# Access Compliance Report

## Public Rights-of-Way

Intersection ID: 53236	Main Street: FLEETWOOD_DR	Cross Street: DOLLY_MADISON_RD	Location: SE
ADA ID: 2837621026A8	Ramp Type: Perp	Initial Pass/Fail: Fail	Overall Compliance: No
		Severity Score: 12.5

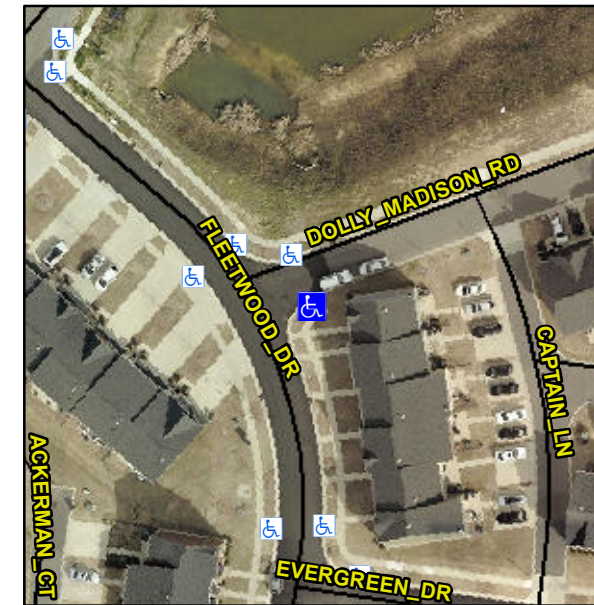
**Not Found, R304.2.2**

Compliance	Description	Data	Compliance	Description	Data
N/A	Ramp Length (in)	70.5	No	Ramp Slope (%)	9.1
Yes	Ramp Width (in)	48.5	Yes	Ramp XSlope (%)	1.2
N/A	Flare Type LT	N/A	N/A	Flare Type RT	N/A
N/A	Flare Slope LT (%)	N/A	N/A	Flare Slope RT (%)	N/A
N/A	Flare Traversable LT?	N/A	N/A	Flare Traversable RT?	N/A
N/A	Landing Length (in)	N/A	N/A	DWS Provided?	N/A
N/A	Landing Width (in)	N/A	N/A	DWS Contrast?	N/A
N/A	Landing Slope (%)	N/A	N/A	DWS Length (in)	N/A
N/A	Landing X Slope (%)	N/A	N/A	DWS Full Width?	N/A
N/A	Landing Curb? (Y/N)	N/A	N/A	DWS Offset (in)	N/A
N/A	Shared Landing?	N/A			
N/A	Gutter Ponding?	N/A	N/A	Gutter Slope (%)	N/A
N/A	Gutter Lip Ht (in)	N/A	N/A	Gutter X Slope (%)	N/A
N/A	Painted X Walk1?	No	N/A	Painted X Walk2?	N/A
	X Walk 1 Direction	To N		X Walk 2 Direction	N/A
N/A	X Walk 1 Width (in)	N/A	N/A	X Walk 2 Width (in)	N/A
	X Walk 1 Slope (%)	1.5		X Walk 2 Slope (%)	N/A
	X Walk 1 X Slope (%)	2.9		X Walk 2 X Slope (%)	N/A

**Remove & Replace Entire Ramp.**
